- **VIBRATION—FROM DRIVELINE—4X2 VEHICLES WITH 4R70W AND 139 INCH WHEELBASE**
- **TRANSMISSION—4R70W—FLUID LEAK FROM EXTENSION HOUSING SEAL—4X2 VEHICLES WITH 139 INCH WHEELBASE**

**Article No. 01-9-3**

**FORD:** 1997-2000 F-150, F-250 LD

Figure 1 - Article 01-9-3

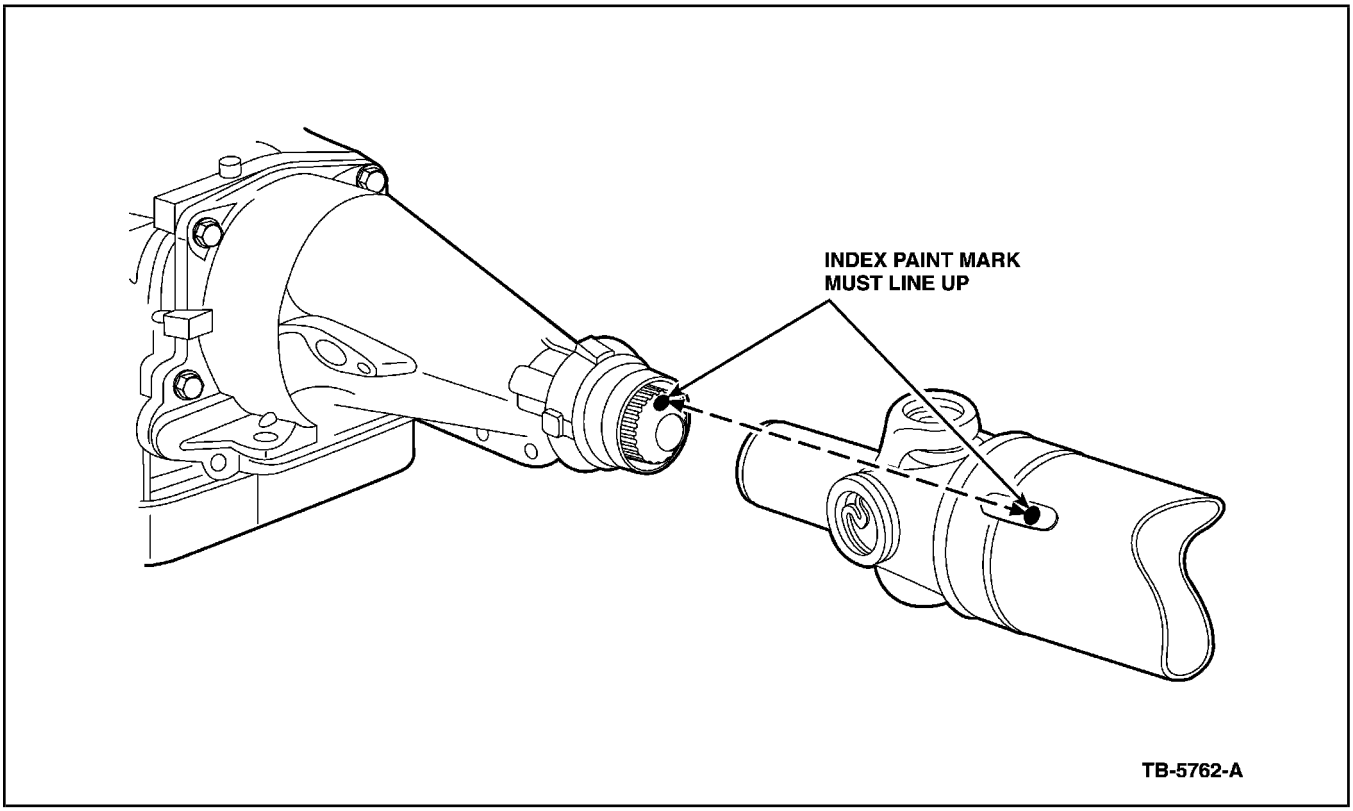
**ON VEHICLES BUILT AFTER 4/1/1998, THE INDEX PAINT MARKS ON THE OUTPUT SHAFT, DRIVESHAFT, AND REAR AXLE MUST BE ALIGNED. THE INDEXED BALANCE MARK ON THE OUTPUT SHAFT AND THE INDEXED BALANCE MARK ON THE NEW DRIVESHAFT YOKE MUST BE ALIGNED (FIGURE 1). ALIGNMENT OF THE INDEX MARKS ON THE REAR DRIVESHAFT TUBE AND THE REAR AXLE FLANGE MUST BE PERFORMED (FIGURE 2).**
